SERVICE ADVISORY # 15-227

Summerland Mini Fuse

Fig. 1

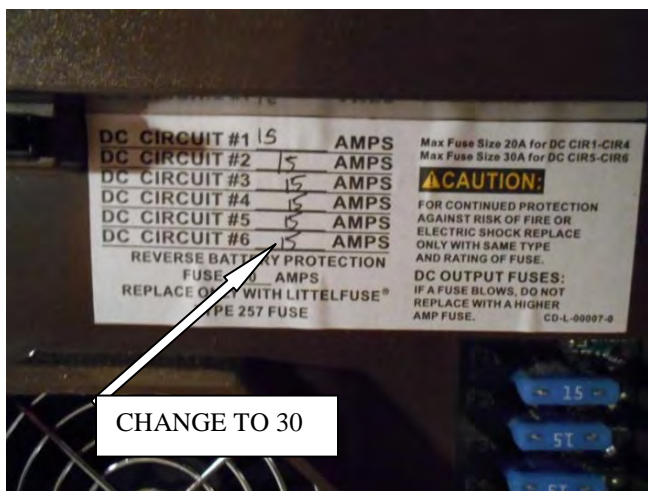
It has been determined the below listed vehicles were manufactured with an undersized 15 amp fuse placed in the battery charging circuit which should have a 30 amp fuse. The circuit is wired and rated for 30 amp capacity. This advisory explains how to correct.

Step 2 Locate the fuse panel in the unit. Remove the 15 amp fuse from the number 6 location of the fuse panel. Replace the fuse with a 30 amp fuse. Change the noted fuse size of position 6 on the information label from 15 to 30.
